RECEIVED  
FEB 13 1984  
DEPARTMENT OF PLANNING  
Subdivision Section  
**REVISED P.O.A.D.P.**  
Sent copy to all of Plan 2. 14-83

WOODS OF SHAVANO & UNIVERSITY OAKS  
DEVELOPMENT PLAN

INFORMATION SHEET FOR  
PRELIMINARY OVERALL AREA DEVELOPMENT PLAN  
(P.O.A.D.P.)

INFORMATION SHEET FOR  
P.O.A.D.P.

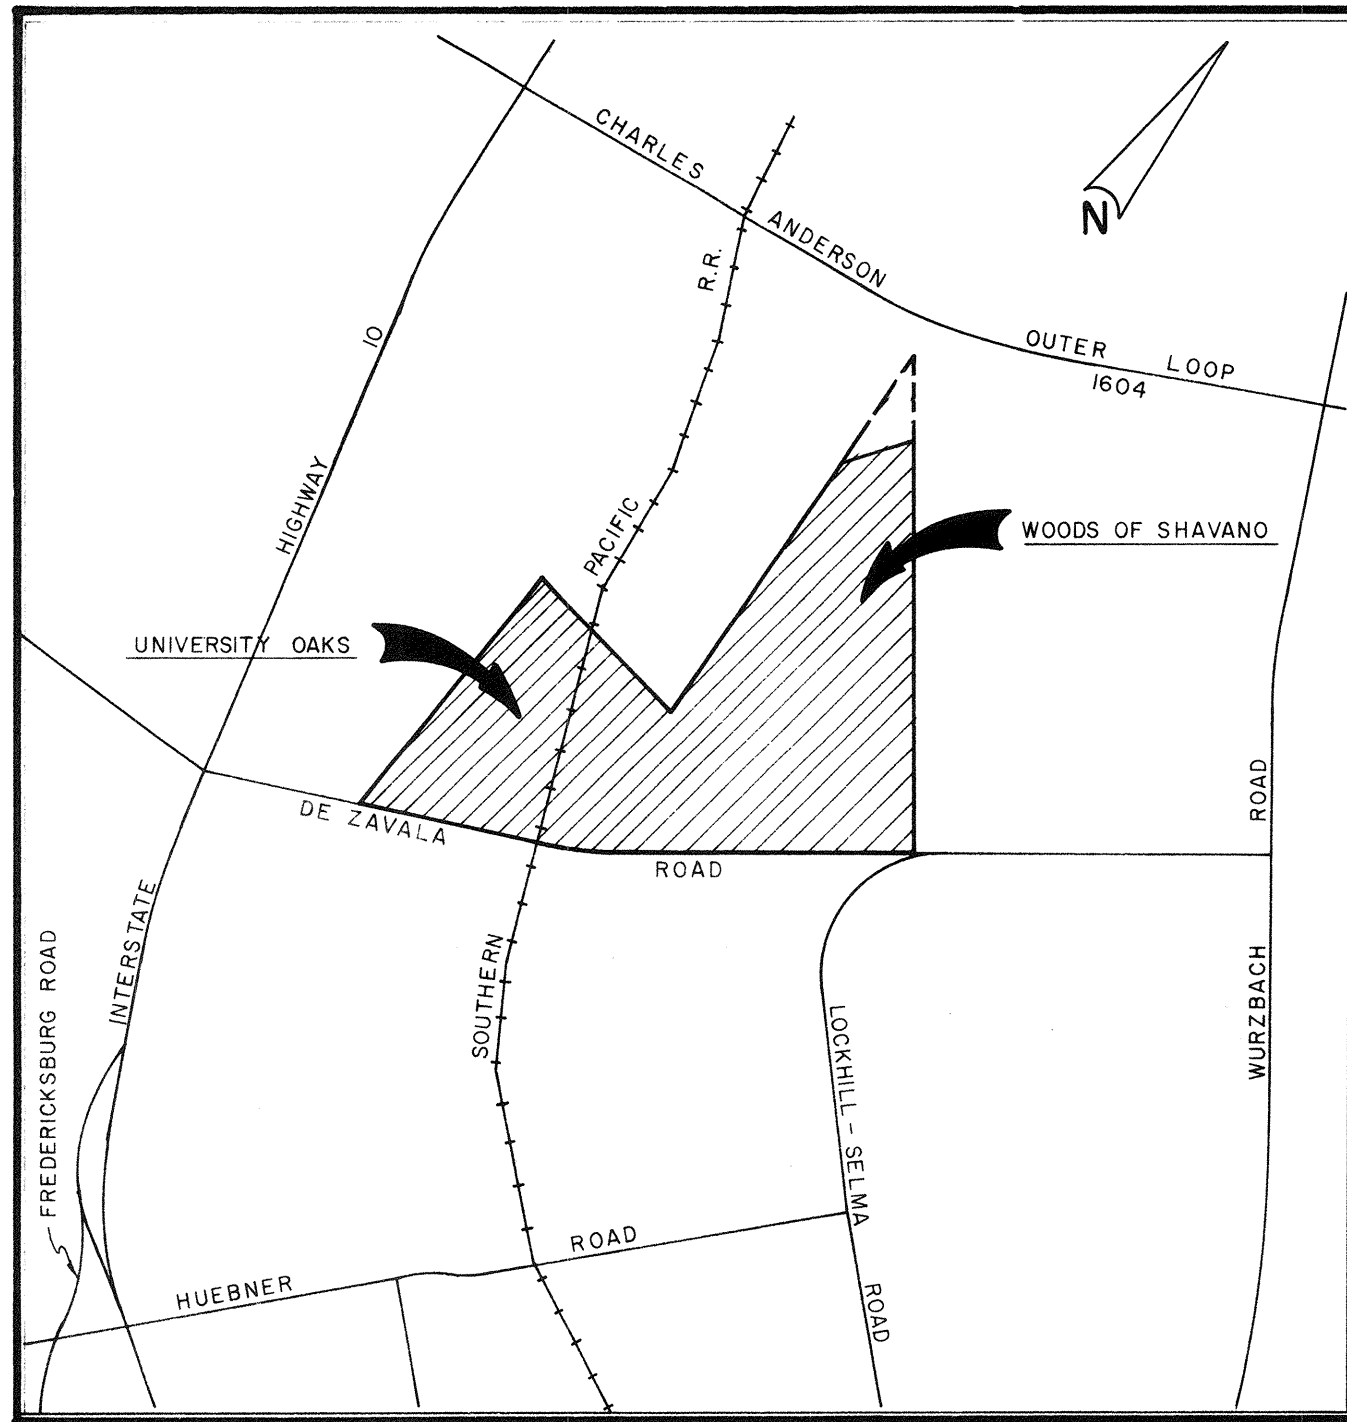
2-21-84  
Advised committee  
of changes was  
approved. Revised  
map was then  
submitted. The  
P.O. had already  
approved the  
preliminary map and  
approved the revised plan was  
submitted to update P.O.A.P.

# WOODS OF SHAVANO & UNIVERSITY OAKS DEVELOPMENT PLAN

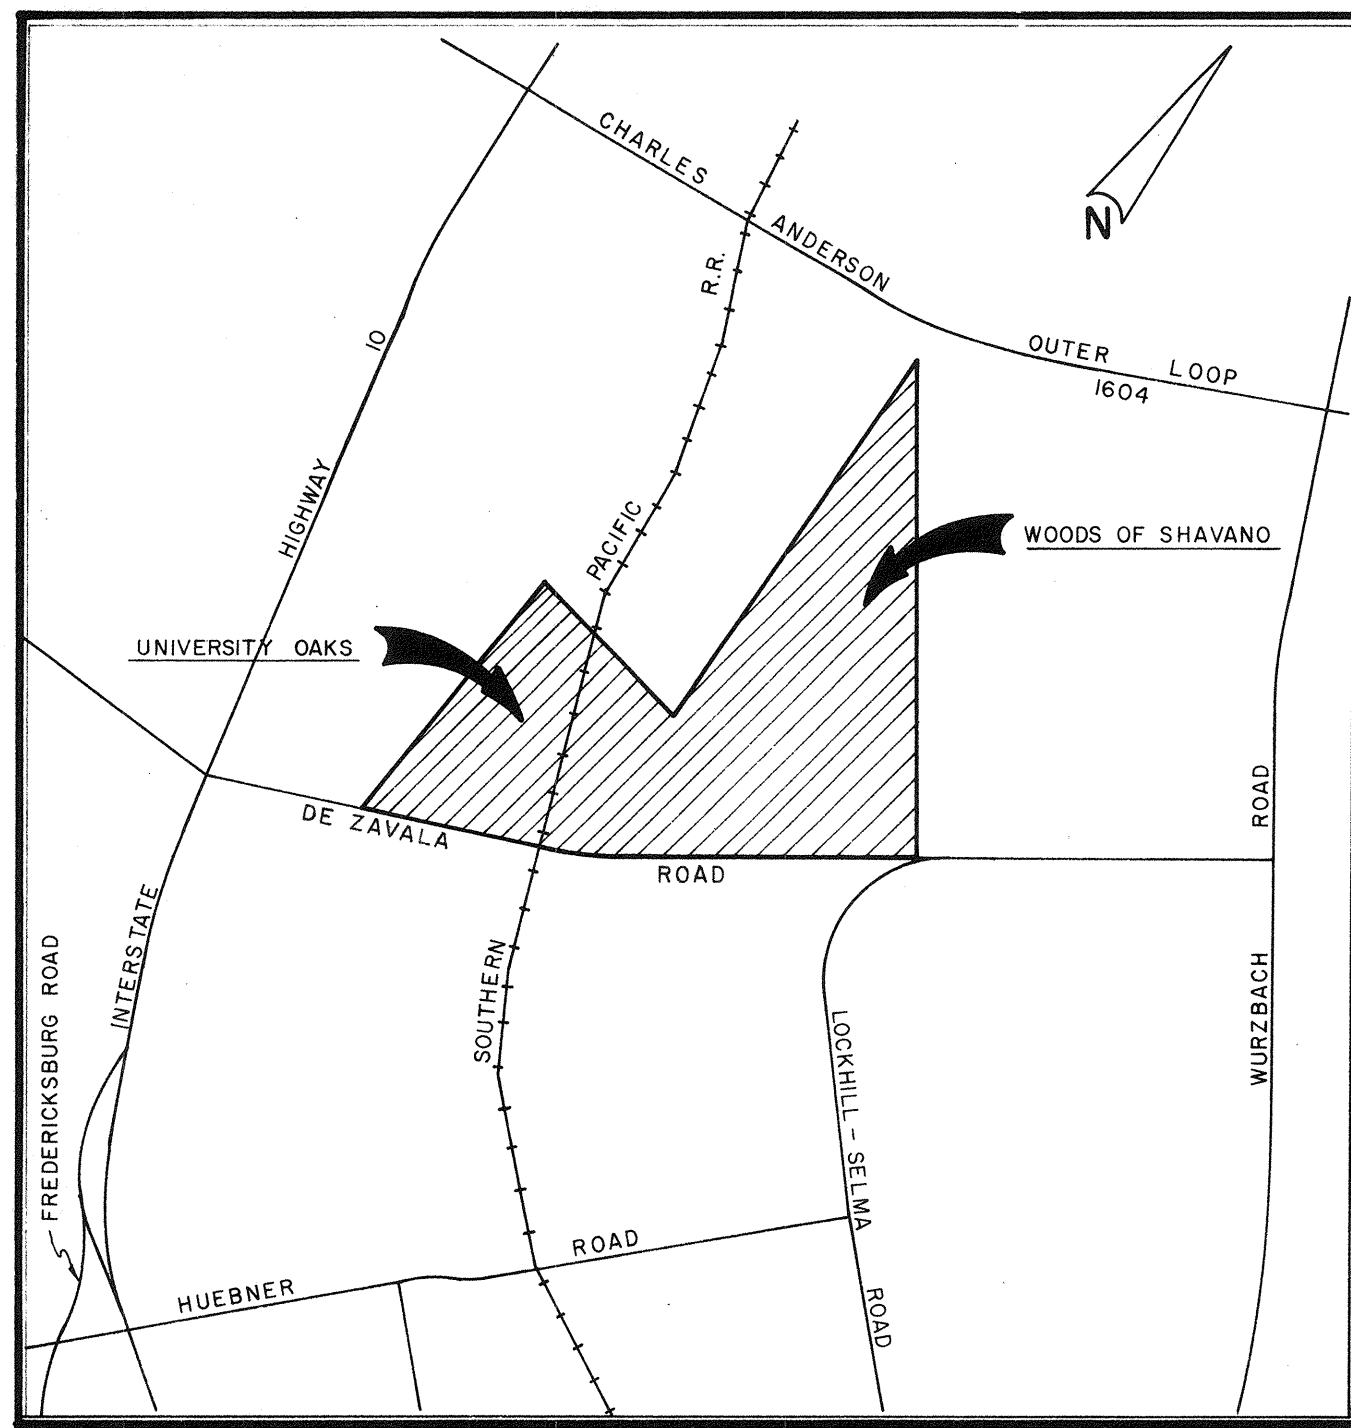
SHOWED 11 AC. TR. THAT WAS ENCOMPASSED BY UNIVERSITY DARES

BUSINESS PARK AT YOUR REQUEST. IF YOU HAVE ANY QUESTIONS CALL US.

(X) Comments: Your POADP has been reviewed and accepted by  
the POADP Committee.
